PLANNING AND ZONING COMMISSION MEMORANDUM

SUBJECT: SDP 2020-02 Public hearing and consideration of a request from Urban Trails Beaten Path Development for a revised special development plan for Urban Trails at northwest and northeast corners of Mid Cities Boulevard and Holiday Lane, being 10.92 acres described as Urban Trails Addition Phases One and Two.

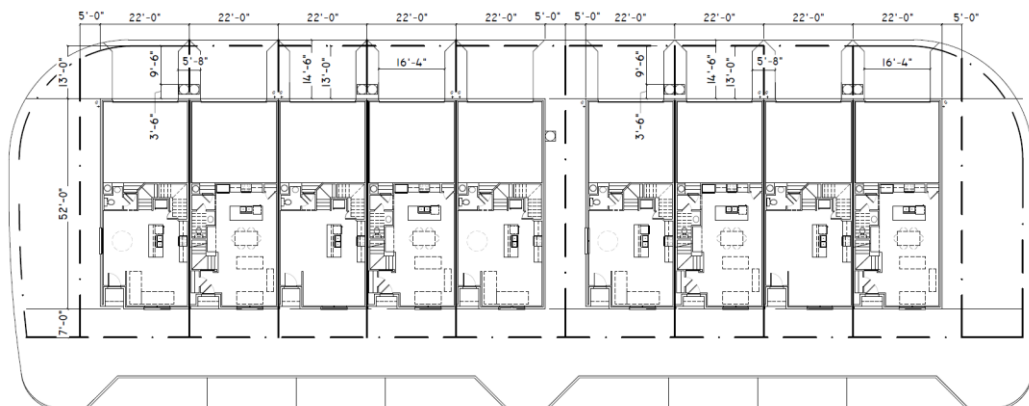
Architectural design. As part of the presentation of the special development plan to City Council in 2018, the applicant presented conceptual building elevations that illustrated the basic architectural design features for the interior townhomes and the duplex units facing Mid-Cities Boulevard. The applicant agreed to incorporate specific elevations into

the approved standards for the Mid-Cities duplex units, contingent on refining and enhancing the design of the product with staff.

The images below illustrate the approved and proposed design features for the duplex units. Since the original approval did not specify the types of required features, the applicant proposes to include the following as part of the revised SDP.

STAFF REVIEW: The Development Review Committee generally supports the requested revision to the first floor ceiling height due to previous approvals for reduced 22-foot townhome width affecting the livable floor area. The Development Review Committee also supports the proposed modifications to the architectural concept renderings.
